ATLASSIAN CENTRAL DEVELOPMENT

SSD-10405 RESPONSE TO SUBMISSIONS & SUPPLEMENTARY DESIGN REPORT

30/06/21

FIGURE 2 - SHADOW STUDY WITH RESIDENTIAL LOCATIONS ON CARLTON & KENSINGTON STREETS

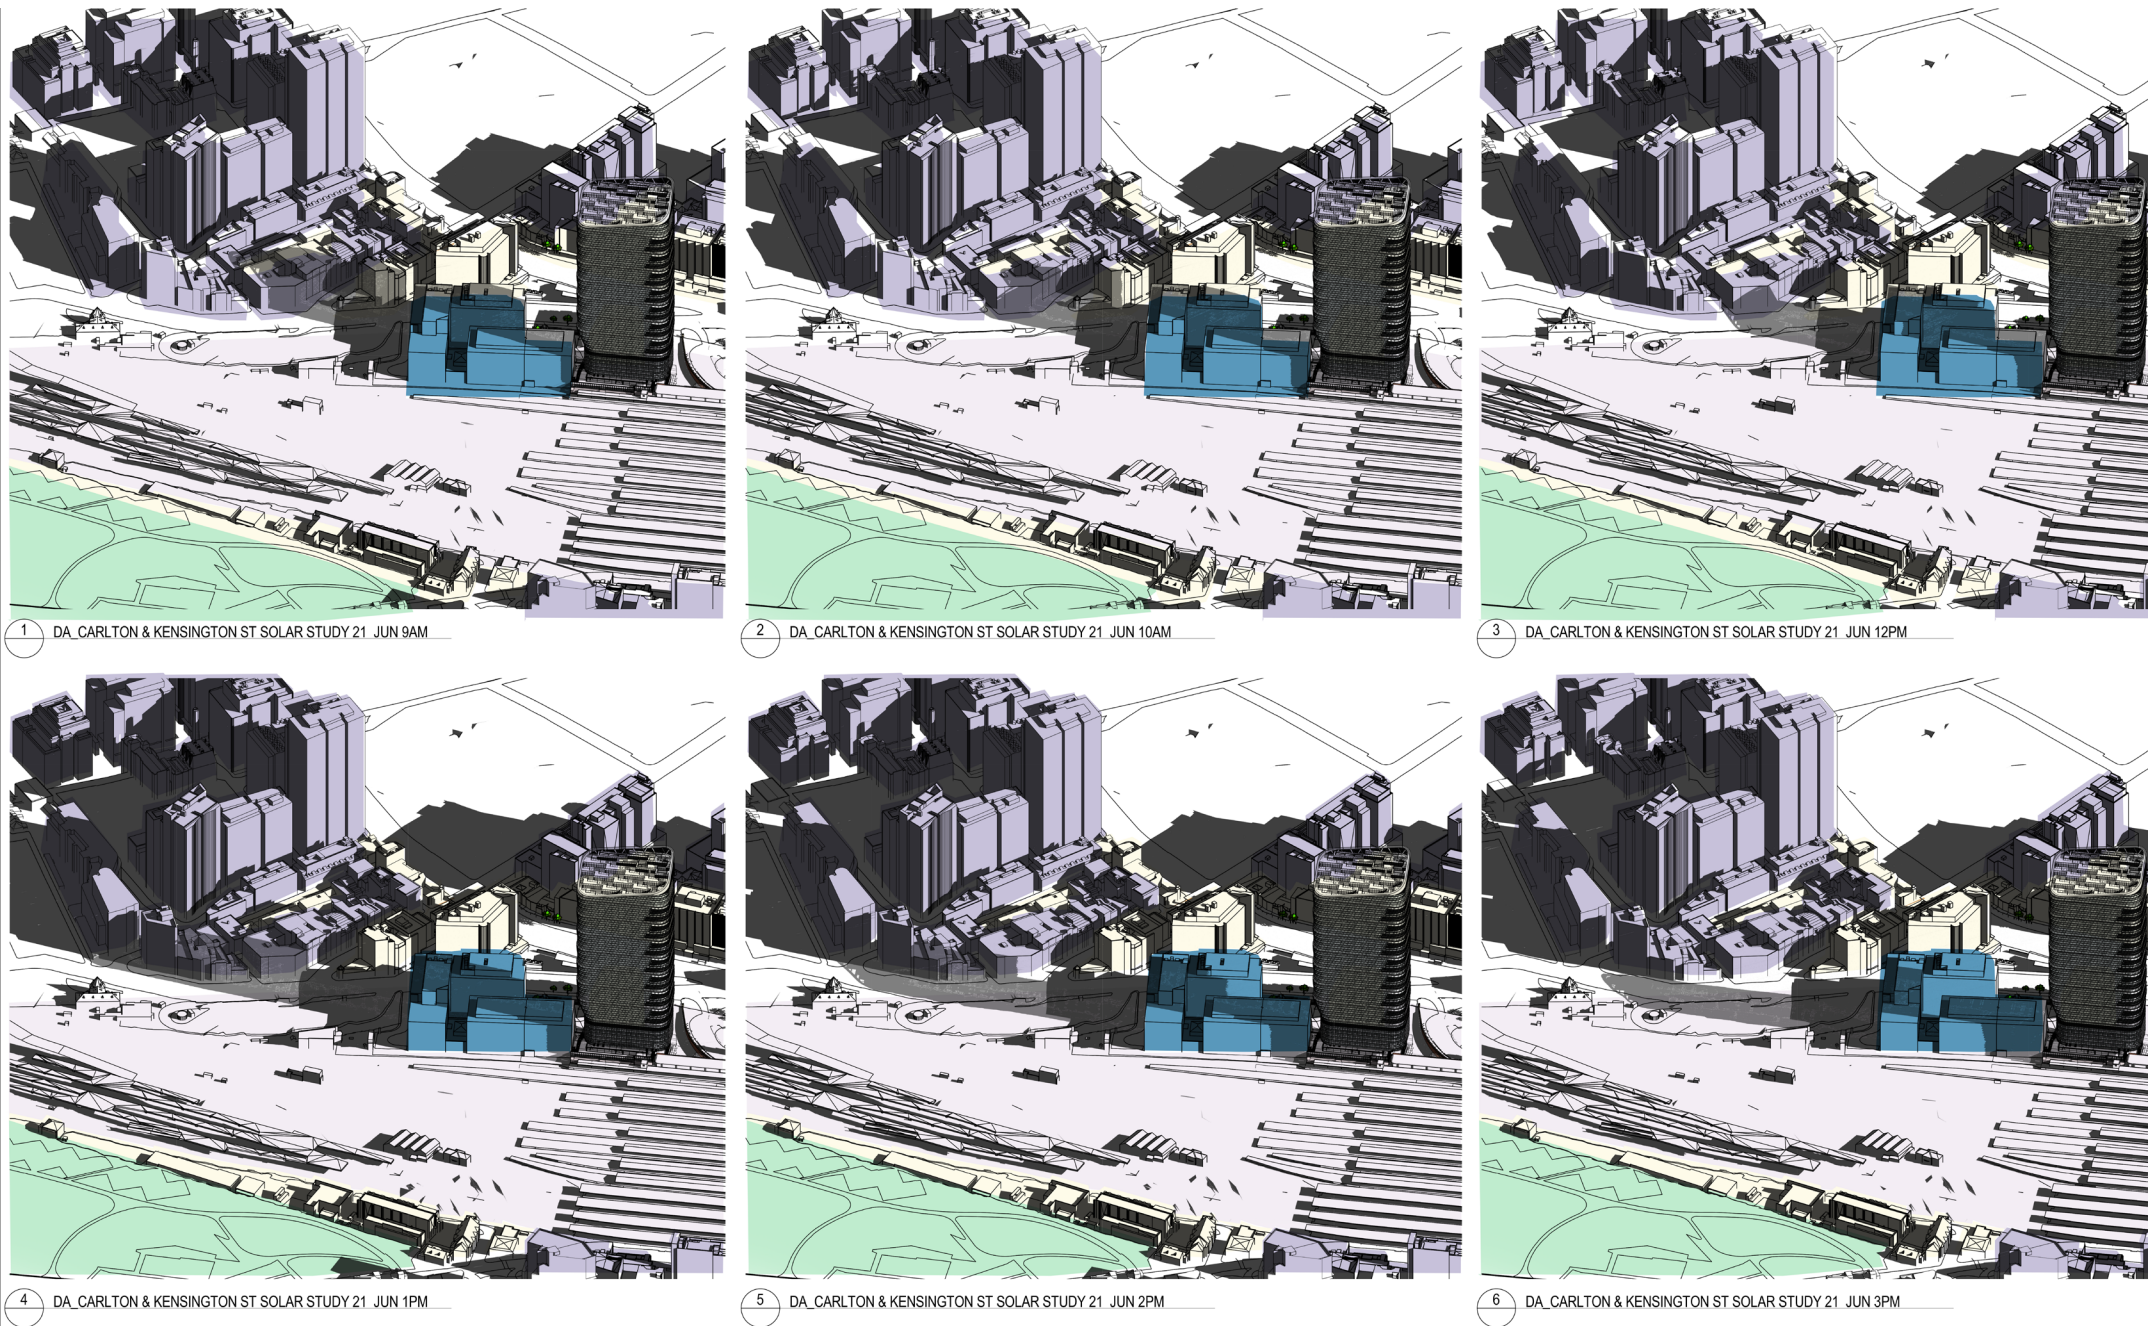
DPIE Comments		Response
Design Excellence		
In addition to responding to the GANSW concerns and recommendations, the proposal should be presented to the Design Integrity Panel (DIP) to assist with resolving the design issues. Please provide a copy of the DIP advice/meeting minutes.		Noted.
Overshadowing		
Further consideration should be given to the positioning and/or design of the roof terrace balustrading. In particular, options should be explored to avoid penetration into the sun access plane to protect solar access to Prince Alfred Park, having regard to the concerns raised by Council and GANSW.		Refer to Commment 1.1.1 and 1.1.2.
Residential Amenity		
Provide further analysis of potential amenity impacts on nearby residential properties including: - A map identifying properties in the vicinity of the site - An assessment of visual and view impacts on affected properties, particularly in relation to properties located on Carlton and Kensington Street identified as being affected by view loss of the clock tower, against Tenacity view sharing principles - An assessment of overshadowing impacts on private residential properties to the west and south west against the Apartment Design Guide (ADG) minimum solar access guidelines.		Refer 1.6.1 DPIE Comment

A vicinity map has produced to identify potential residential properties affected on Carlton and Kensington streets. See Figure 1

The shadows for these areas show that the proposed tower will shadow the residential properties at the southern end of Regent street on the corner with Lee Street from 9am -10am but will has access to sun from 10-3pm. See figure 2.

The residential properties in Carlton and Kensington streets will not be affected by the proposed tower between 9am and 3pm on the 21st of June.
